MEMORANDUM

DATE: 17 May 2016

SUBJECT: (JRPP no 2016STH013) DA16/0135 Electricity Generating Works (Solar

Energy System) and 3 Lot Torrens Title subdivision and 260 Lot

Figure 1. Bomen Solar project sites and archaeological sensitivity map

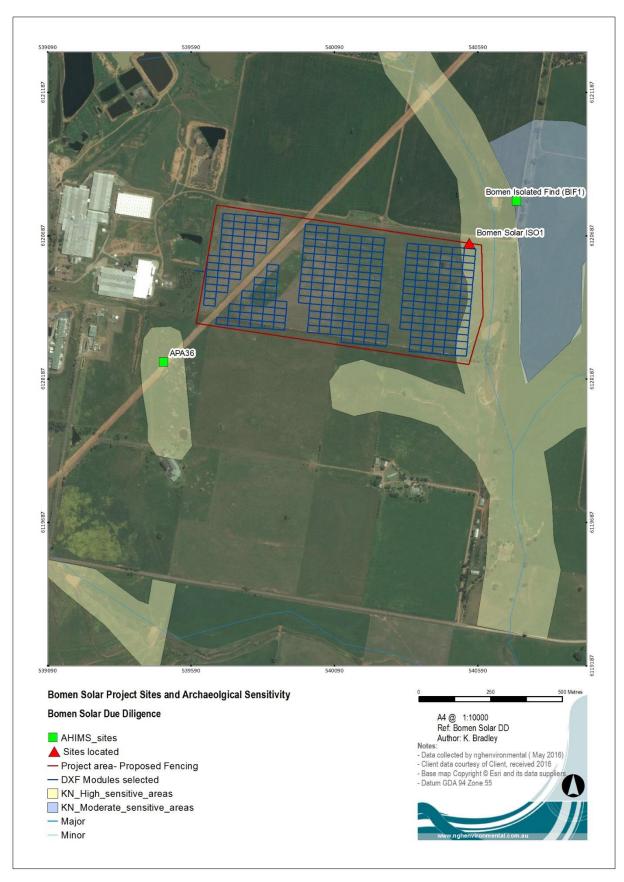
A single site, Bomen Solar ISO1, consisting of two quartz flakes was located in the north-eastern corner of the project area along the proposed fence line alignment. The site is located within the area mapped as having high archaeological sensitivity by Kelleher and Nightingale (2008). The recording of Bomen Solar ISO1 in correlation with the close proximity of Bomen Isolated Find (BIF1) in this area of mapped archaeological sensitivity suggest that there is potential for archaeological deposit (PAD) in this area. The only feasible way to accurately determine the presence, nature and extent of Aboriginal sites within the area of mapped archaeological sensitivity would be to conduct subsurface investigations by test pitting.

The field assessment, combined with the results of archaeologically sensitive mapping from previous studies conducted by Kelleher and Nightingale (2008) in the Bomen area have identified the presence of a single site containing two Aboriginal artefacts, Bomen Solar ISO1, along the alignment of the proposed fence line. In addition, an area of archaeological sensitivity, identified as area of potential archaeological deposit in the eastern portion of the Bomen Solar Energy System development project area has also been identified.

The presence of the site Bomen Solar ISO1 within the area mapped by Kelleher and Nightingale (2008) as having high archaeological sensitivity supports the likelihood that this area contains artefacts. Therefore, any development of the eastern portion of the project area within the area mapped as being archaeologically sensitive is likely to impact on Aboriginal heritage objects. The only feasible way to accurately determine the presence, nature and extent of Aboriginal sites within the area mapped as archaeologically sensitive would be to conduct subsurface investigations by test pitting.

- 1. The proposed construction of the Bomen Solar Energy System can only proceed within the eastern portion that intersects the area of archaeological sensitivity and Bomen Solar ISO1 if an AHIP is obtained from OEH.

- 5. If Southern Cross Energy redesign the project to avoid the potential for impact to Aboriginal objects by including a 50 m buffer to the areas of archaeological sensitivity, this would avoid the need for further investigation or approval.

RAWING				
	EXIS	TING	SITE PLAN	
PROJECT NUMBER:	214082	DRAWING NUMBER:	05G_TP02	REV. G
SOURCE:	INTERNAL

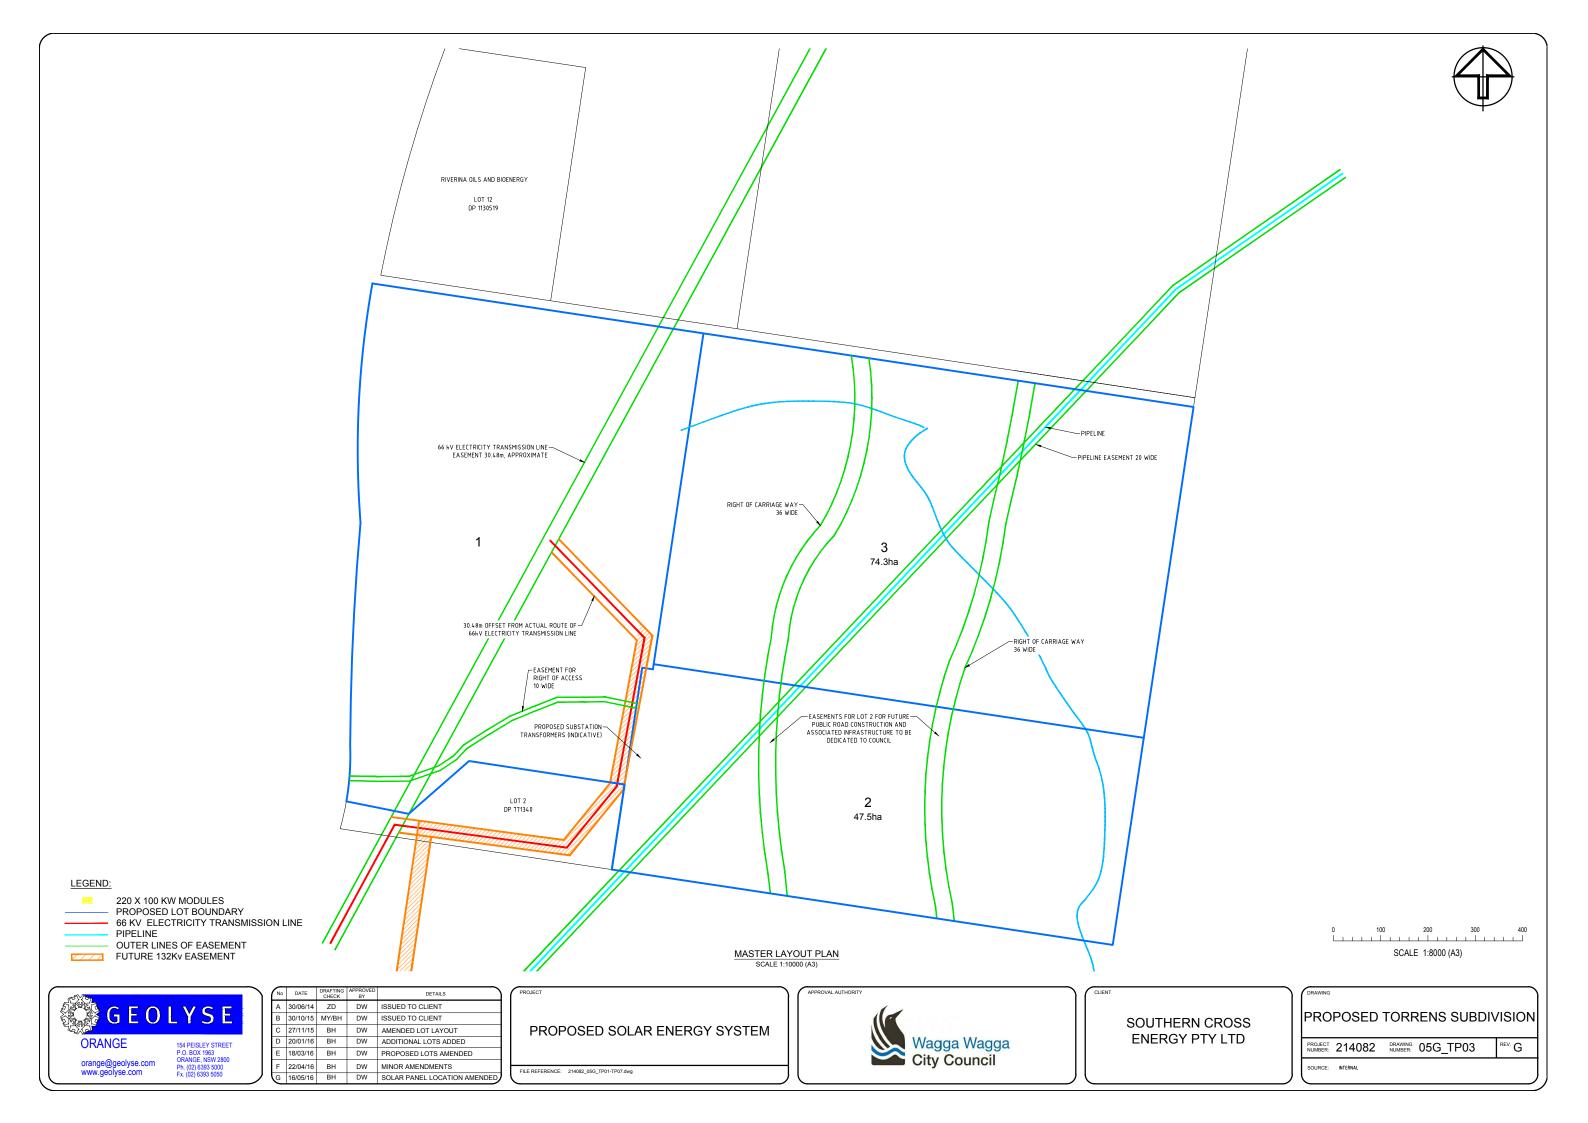
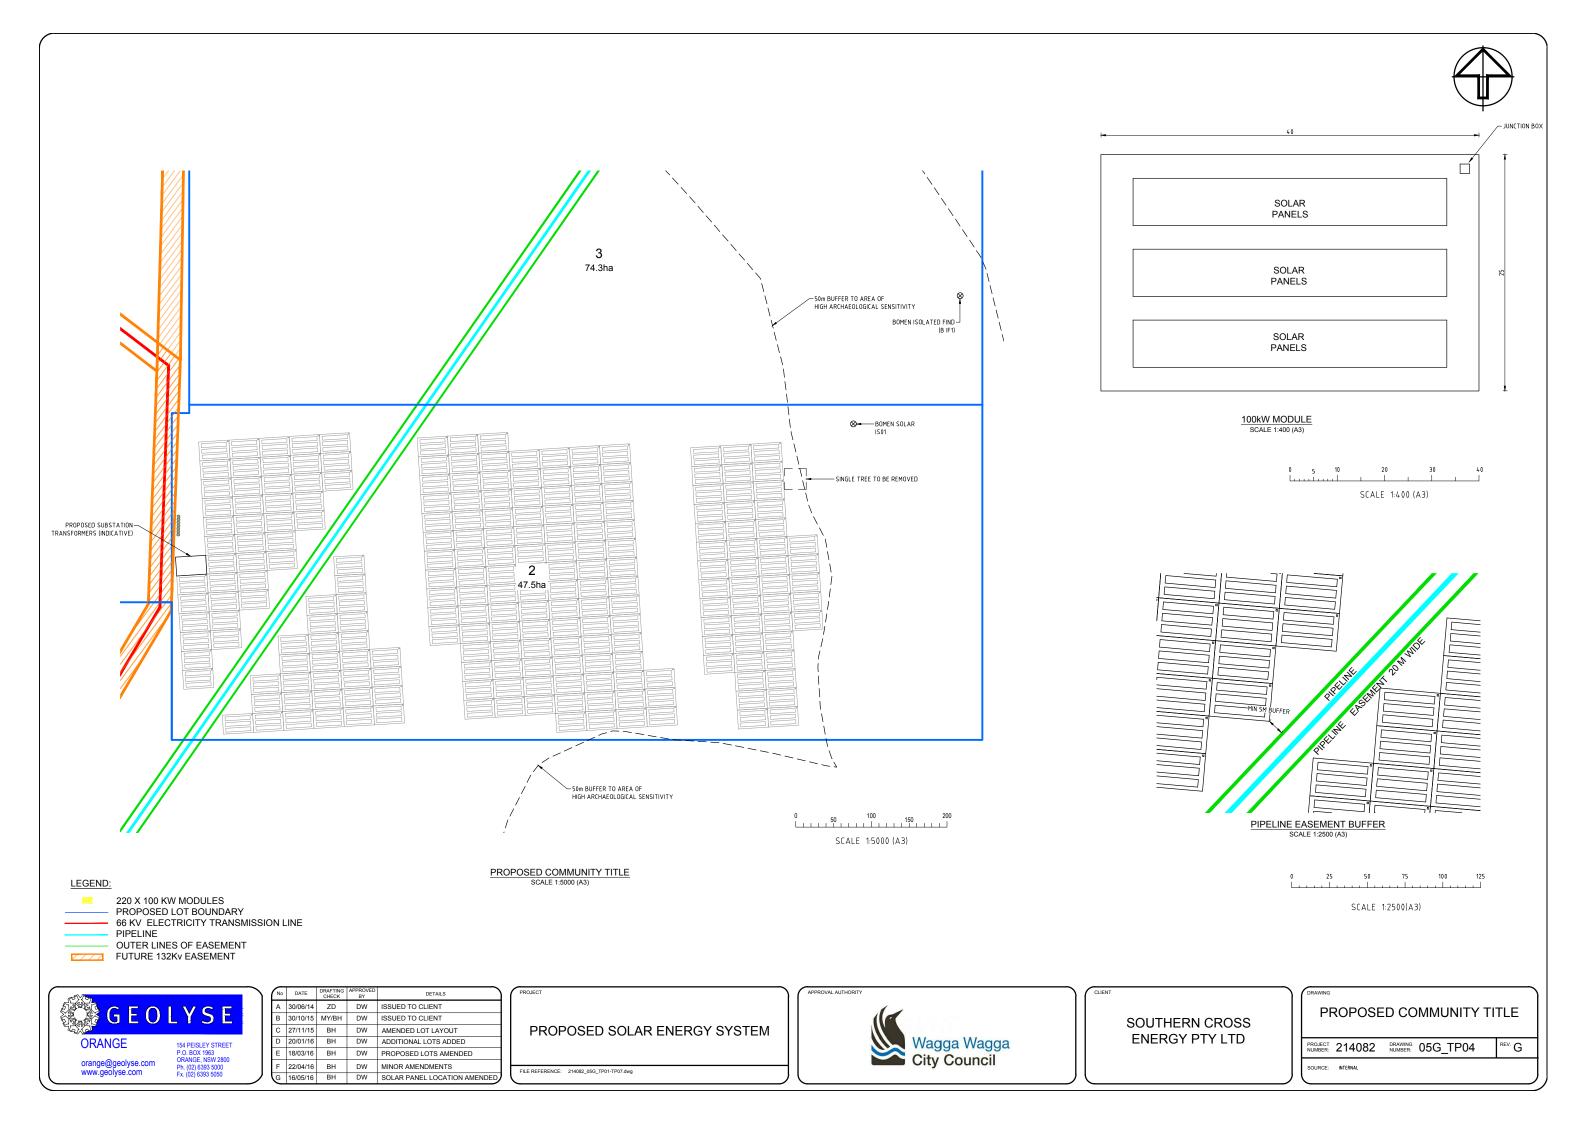
Subsequently the plans were amended in consultation with OEH and Council officers to ensure that the proposed development footprint is clear of the identified objects. The proposed footprint of the development has been reduced and as such the number of modules has reduced from 260 to 220. This results in a reduction from 26MW to 22MW. The overall number of panels has reduced from 85,800 panels to 72,600.

- ngh environmental undertook a site inspection and due diligence assessment of the proposed site on 12
 May.
- This site visit failed to relocate the previously identified site (AHIMS # 56-1-0109) but did locate a new
 location in close proximity to the original design (named Bomen Solar ISO1). Based on these sites and the
 information detailed in Kelleher and Nightingale (2008), they also concluded that the eastern portion of the
 property is a Potential Archaeological Deposit (PAD).
- They made a series of recommendations based on this assessment, which included further assessment and application for an AHIP if the PAD was to be impacted, or measures, including redesign, to avoid impacts on the site.
- Based on this information, Southern Cross Energy has chosen to redesign the solar panel array to avoid impact on the PAD, leading to a reduction of 40 panels for the project.

We support the current proposal to avoid impact on the sites identified. As stated in our previous letter to Wagga Wagga City Council, the proposed conditions of approval 3 and 27 are adequate to address the requirements for ACH where the impact is to be avoided. Condition 3 requires the development of a CEMP including details relating to ACH management. A key component of the CEMP will be the installation of the fencing prior to construction to minimise the potential damage to the PAD. Condition 27 relates to an unexpected finds protocol during construction, and is appropriate (though as previously stated the Note may not be required). The proposed Condition 20, relating to no-harm zones may not be necessary as this may have been dealt with during the site assessment, and the CEMP should include clear procedures to ensure that harm does not occur. However, OEH has no concerns if this condition is retained.
